JZ24-43 MARIELLA ESTATES LOCATION

FORMAL PRO PLAN

PLANNING REVIEW

Rezoning Request from RA Residential Acreage to R-1 One Family Residential with a Planned Rezoning Overlay

SCALE 0 25 50
1" = 50 FEET
SK. SK. CH. CR
P.M. CR
BOOK
JOB 230022817
SHEET NO. 05

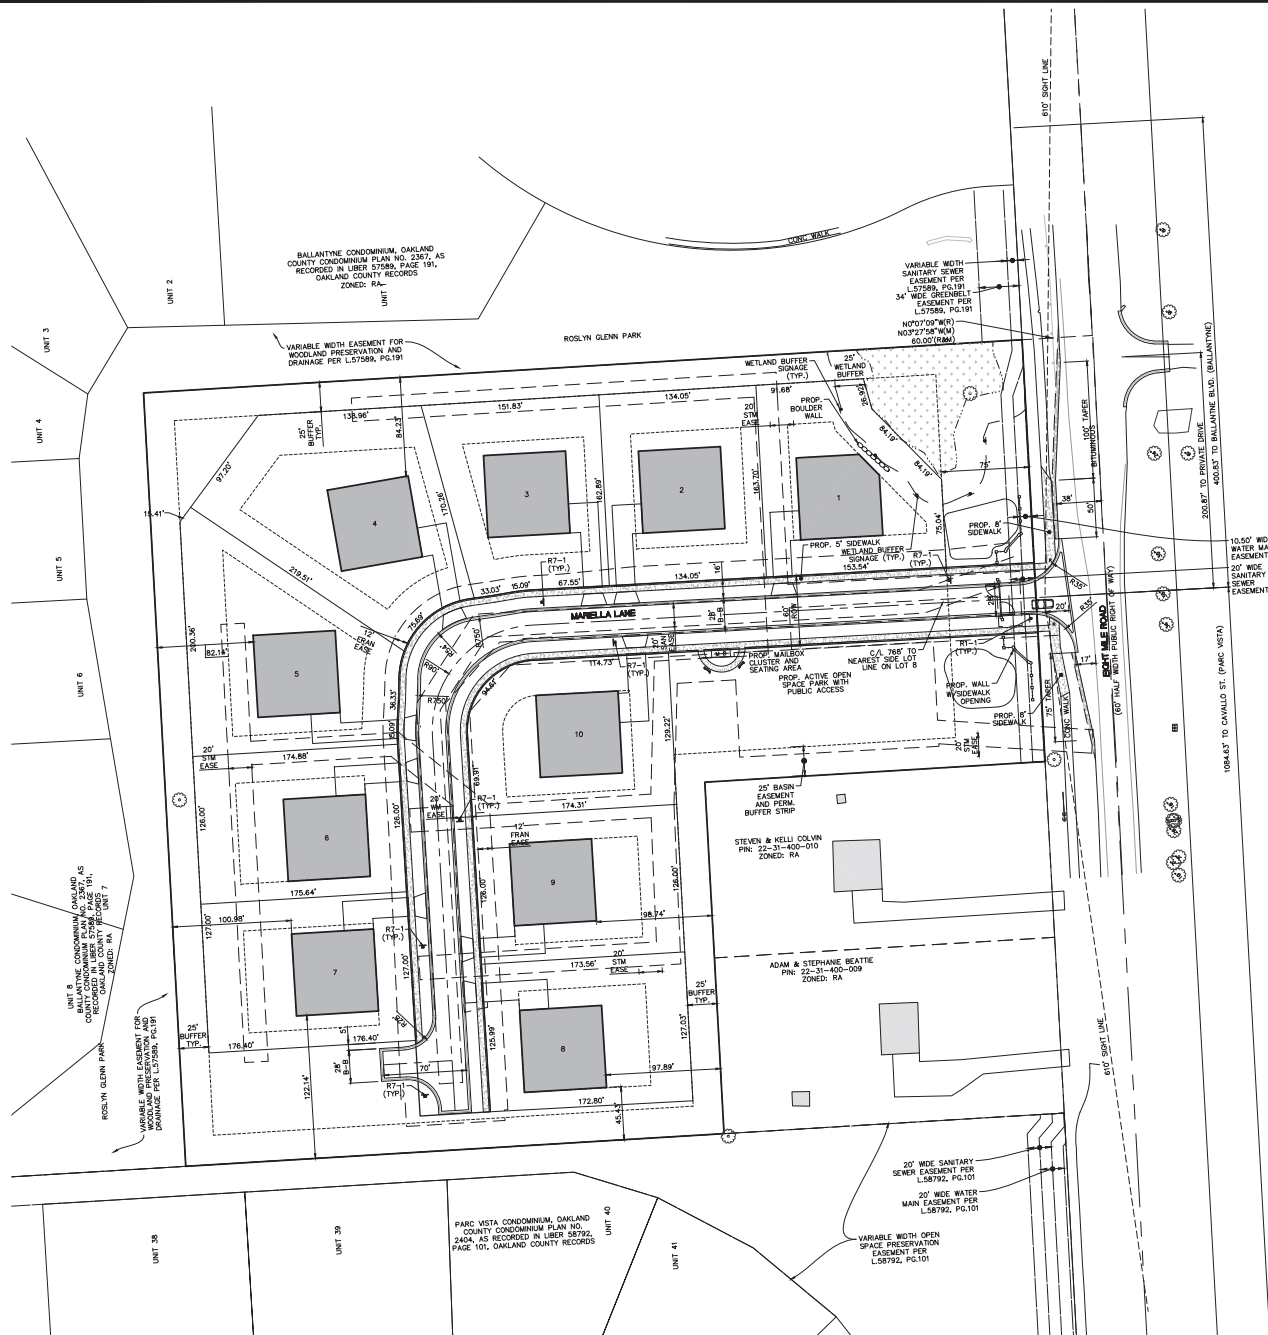
- **All fire hydrants *MUST* be installed and operational prior to any combustible material is brought on site. **IFC 2015 3312.1.** **ONE additional hydrant is needed near lot #1. Sheet #5 only shows 2 hydrants being added to new water main.****

- Fire apparatus access drives to and from buildings through parking lots shall have a minimum fifty (50) feet outside turning radius and designed to support a minimum of thirty-five (35) tons. **(D.C.S. Sec 11-239(b)(5)).** **Sheet #5 indicates 45’ turning radii. Have this updated and include 50’ turning capabilities.**

DR. SK. CH. CR.
P.M. CR.
BOOK
JOB: 23002217
SHEET NO. 04

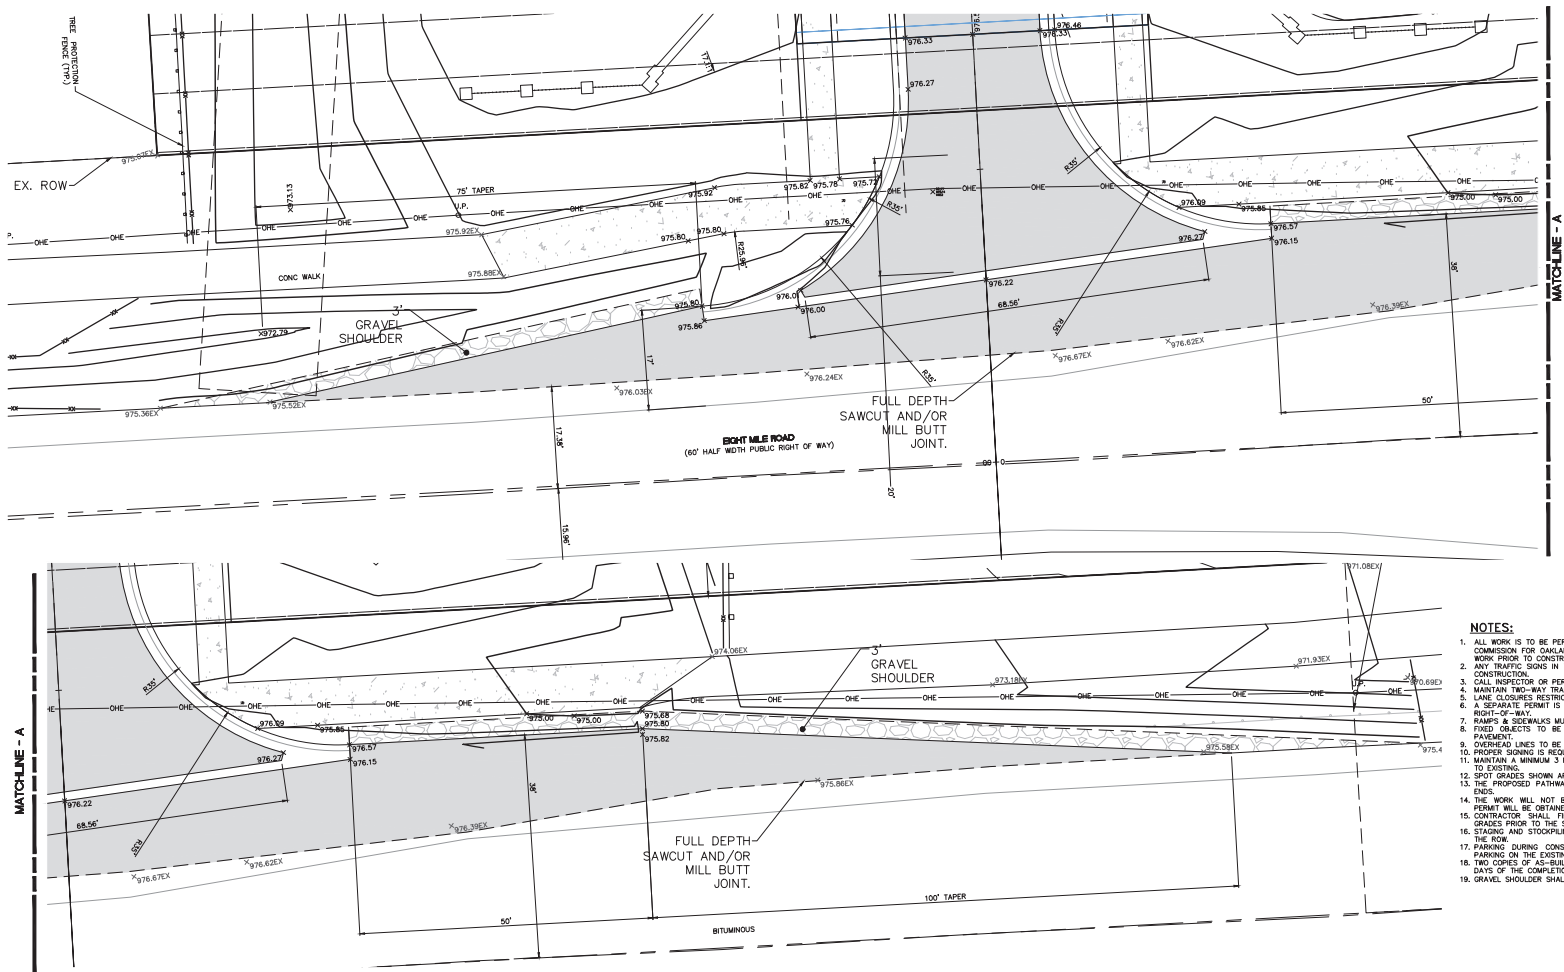
3. Sheet 04 Layout Notes state that the road will not be gated and that roads will be private, the plan shows a gate at the entrance and the road is labeled with 60' ROW. Clarify if roads will be private, revise note to state 60' private road ROW.

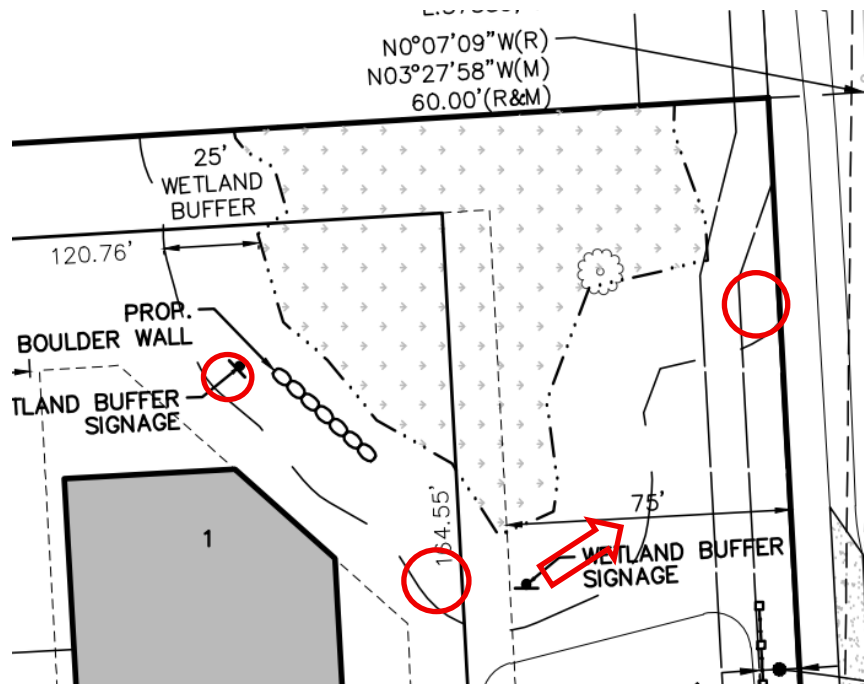
- a. Impacts resulting from the proposed boulder wall should be quantified (cubic yards and square feet) in future submittals.
- b. Impacts from proposed grading should be quantified (cubic yards and square feet) in future submittals. Additionally, if grading is proposed within the wetland setback, it should be identified with a unique symbol.

- c. It is requested that additional wetland and wetland buffer signage be placed around the remaining wetland to ensure the area will not be mowed or disturbed in the future. If possible, the signs should be placed as close to the outside edge of the setback buffer to ensure the full 25-foot setback is not mowed. In future submittals, an example sign rendering should be provided in the site plan. If a conservation easement is placed around the remaining wetland/wetland setback (Comment 4), the signs should indicate that the area is a protected conservation easement.
